AEROCRAFT
COMPANY

SERVICE BULLETIN #4

SUBJECT: FE-30 ELEVATOR WELDMENT

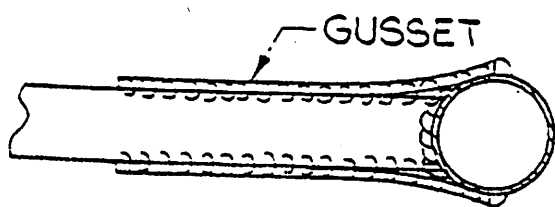
Recently, one builder who has flown his Model 1 KITFOX about 400 hours noticed a crack on the elevator weldment. The crack developed on the spar of the FE-30 at the inboard junction of the trailing edge on the pilot side.

Since this juncture is covered by fabric, you should check this weldment very closely before further flight. Close inspection of this juncture should be a part of every pre-flight inspection.

We have designed gussets that need to be welded to the top and bottom of this spar-trailing edge juncture on both sides of the elevator control horn. We strongly recommend you do this as soon as possible.
